Service Bulletin

Bulletin No.: 24-NA-013

Subject: Steering Pull While Driving and/or Uneven Tire Wear Noticed

Brand:	Model:	Model Year:		Breakpoint:		Engine:	Transmission:
		from	to	from	to		
Cadillac	XT5	2024	2024	November 01, 2023	December 01, 2023	—	—

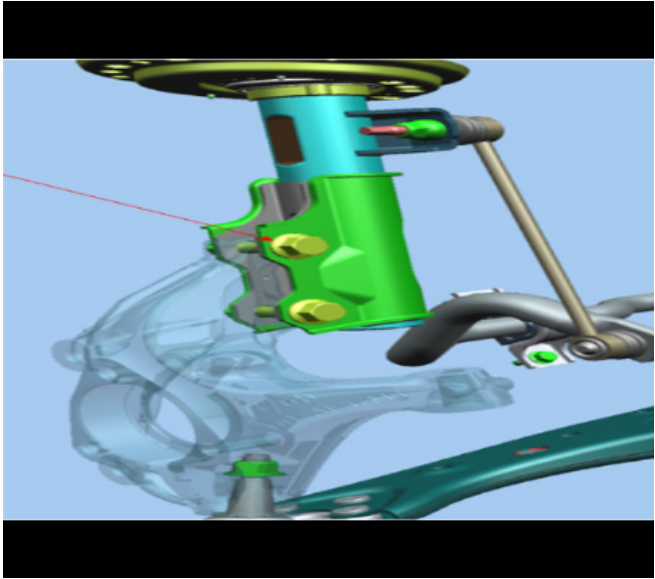
Involved Region or Country	North America, Europe, Kazakhstan, Middle East, Israel, Japan, Cadillac Korea (South Korea)
Condition	Some customers may comment on steering pull while driving and/or uneven tire wear noticed.
Cause	The condition may be caused by the camber is out of spec and does not align with $-0.6^{\circ} \pm 0.5^{\circ}$.
Correction	<div style="text-align: center;">  </div> <p style="text-align: right; font-size: small;">6523918</p> <p>Install the new service bolt, as shown in the picture above, to bring camber back to spec.</p>

Causal Part	Description	Part Number	Qty
X	BOLT, S/KNU (SERVICE CHAMBER ADJUSTMENT BOLT-TOP BOLT) (M12 X 1.75 X 65.9 MM)	11589277	1
